UNITED STATES
NUCLEAR REGULATORY COMMISSION
WASHINGTON, D.C. 20555-0001

SUBJECT: H. B. ROBINSON STEAM ELECTRIC PLANT, UNIT NO. 2 – STAFF
ASSESSMENT OF FLOOD HAZARD FOCUSED EVALUATION AND
INTEGRATED ASSESSMENT (EPID NO. L-2018-JLD-0172)

STAFF ASSESSMENT BY THE OFFICE OF NUCLEAR REACTOR REGULATION
RELATED TO THE FOCUSED EVALUATION AND INTEGRATED ASSESSMENT
FOR H. B. ROBINSON STEAM ELECTRIC PLANT, UNIT NO. 2
AS A RESULT OF THE REEVALUATED FLOODING HAZARD
NEAR-TERM TASK FORCE RECOMMENDATION 2.1 - FLOODING
EPID NO. L-2018-JLD-0172

Figure 3.3-2 – Approximate location of FLEX AFW pumps

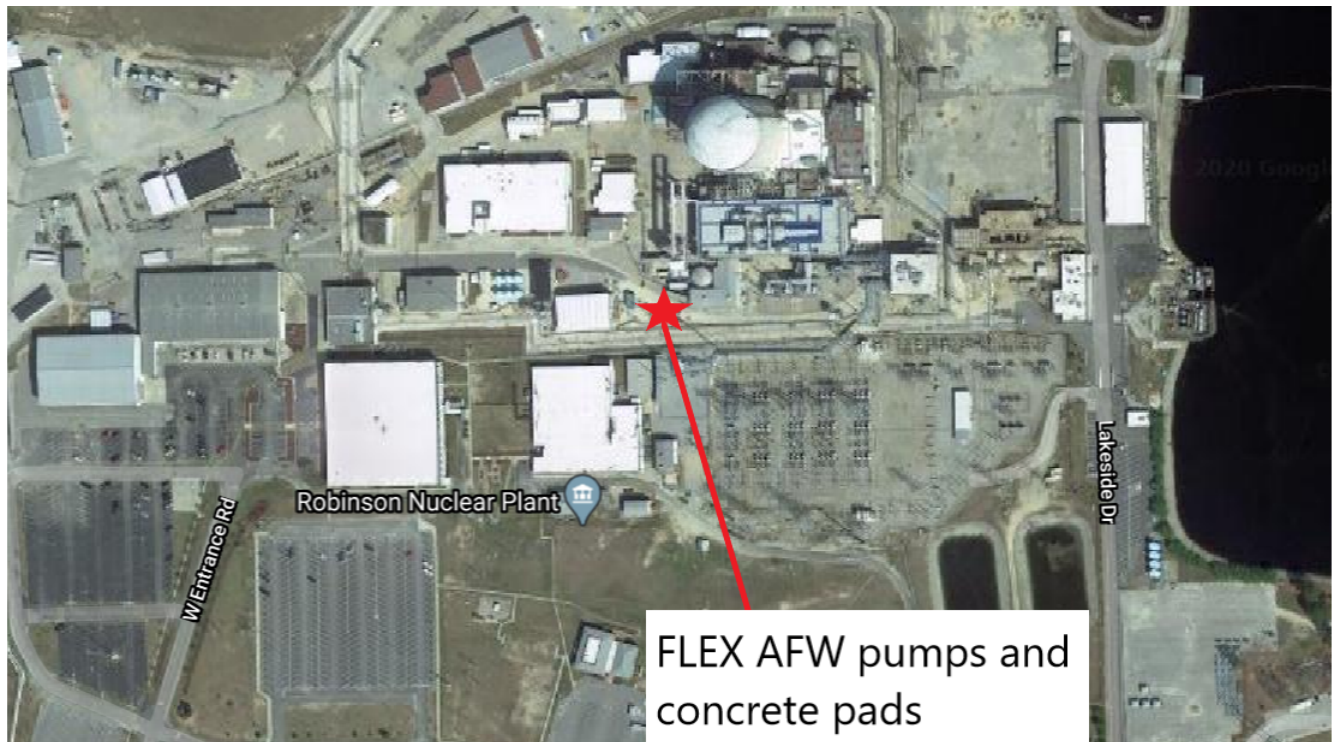
Because the revised streams and rivers hazard no longer causes failure of the UHS, the licensee will deploy a portable low-pressure FLEX pump to use Lake Robinson as the long-term source of cooling water after the depletion of the water in the six AFW tanks and the CST, and refill the suction inventory. In its MSA, the licensee stated that the pumps were not permanently installed, and therefore pre-staged on trailers before the event. In its IA, the licensee stated it has permanently installed the pumps on top of two concrete pads. The concrete pads and pumps are located outdoors in an area southwest of the condensate storage tanks (see Figure 3.3-2).

The NRC staff reviewed EC 413616 and the associated plant sketch, and verified with the licensee that installation of the concrete pads at the site had been completed. The concrete pads are approximately 13 ft. x 23 ft. x 8 in. with several tie down anchors. The finished elevation of slab is designed to be 226.63 ft. or higher. Therefore, when considering that the most vulnerable component of the pump is approximately 3 ft. above the ground, a total flood protection of approximately 229.63 ft. is available. Therefore, when comparing 229.63 ft. against 228.9 ft., and considering all the inherent conservatisms and assumptions embedded in the development of the reevaluated flood hazard, it can be reasonably concluded that the pumps are not impacted by the PMF flood elevations.
